MELLON INSTITUTE

December 13, 1960

This is in reply to your letter of December 5 requesting additional information on our license application for a 100 curie cobalt 60 source.

100 curie
Cobalt 60 source
Source plug

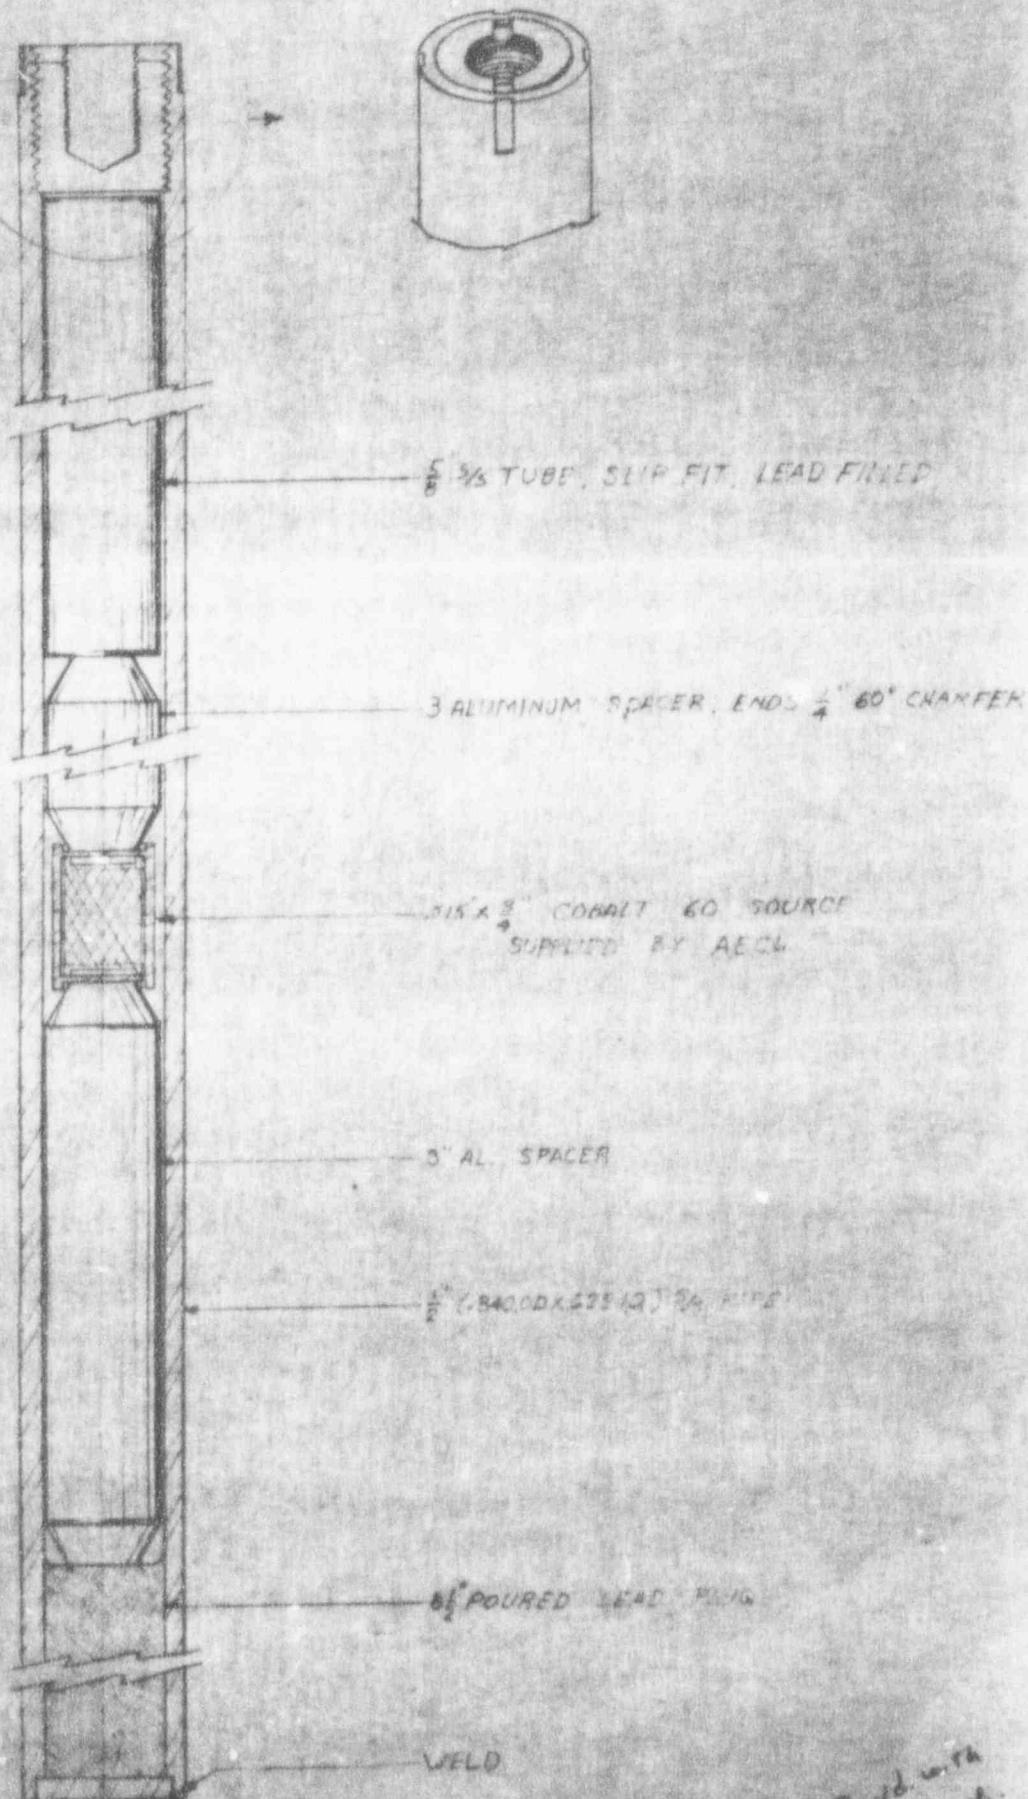
Enclosed are additional sketches which describe the source plug and the raising mechanism. The source will be contained in the plug as per the illustration. This plug will be raised to the operating position inside an extension tube mounted on top of the safe. Raising and lowering will be done via a motor-driven winch. The operating limits will be established via the indicated microswitches. The lower microswitch will also serve to actuate a green light which will clear access to the irradiation chamber. If the lower microswitch is open an appropriate warning light will be actuated as per Section 20.203(C)(2) of CFR-20. Together with the use of closed circuit television to monitor the rod position we believe that this arrangement is fail safe.

In regard to your first question on leak testing, it will be seen from the description of the source plug that there is little possibility of any difficulty on this. The only remote possibility would be through the screwed thread in the top of the plug. This will be appropriately wipe tested.
